PLAN REVIEW SHEET

Date:	12/14/07	Staff Contact:	David McDonald
Petitioner:	Michael Melton	Telephone:	704-336-6900
Petition:	2008-028	Fax:	704-432-1277
		Email:	dmcDonald@ci.charlotte.nc.us
Location:	Approx. 0.39 acres on NE corner The Plaza and Shamrock Dr.	Attachments:	Shelter_Concrete_Standards.pdf (See 60.01A)
Existing Zoning:	B-2(CD)		
Requested Zoning:	B-1(CD) (Build addition and remove condition of use)

FIRST SUBMITTAL

STD. NO.	REV.
60.01A

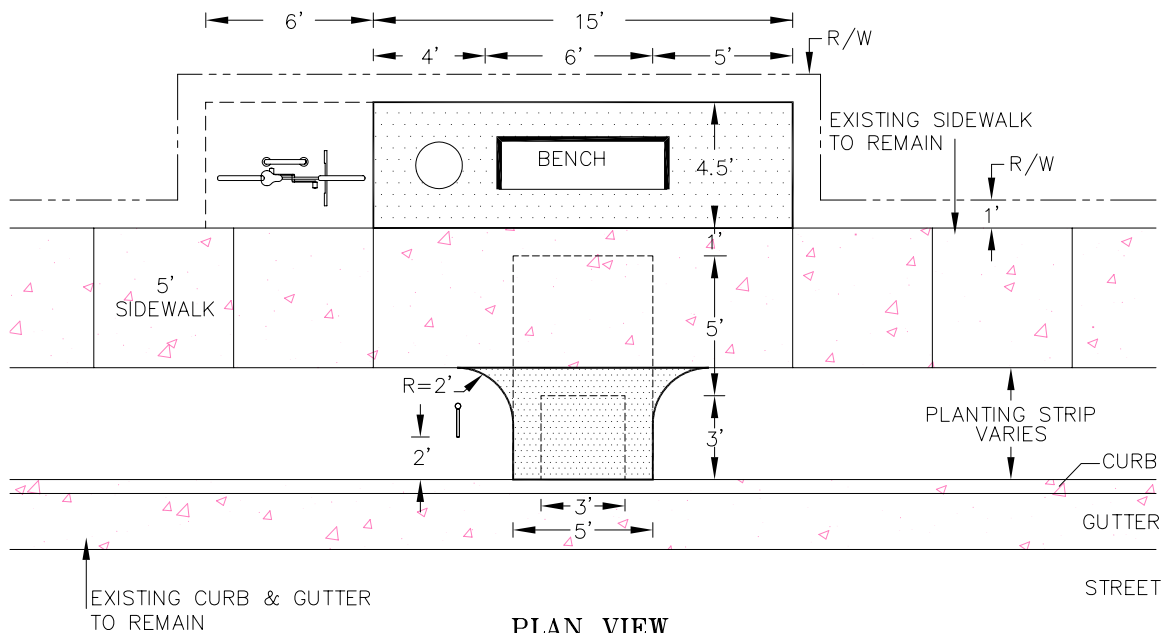
- 1) CATS requests a waiting pad on Plaza Road constructed to CATS Development Standards 60.01 A (see attached).

Please designate such in the site plan and/or accompanying notes. Please contact Leonard Ganther (CATS Operations) @ 704.432.1283 prior to demolition or construction, to coordinate the final location of the waiting pad.
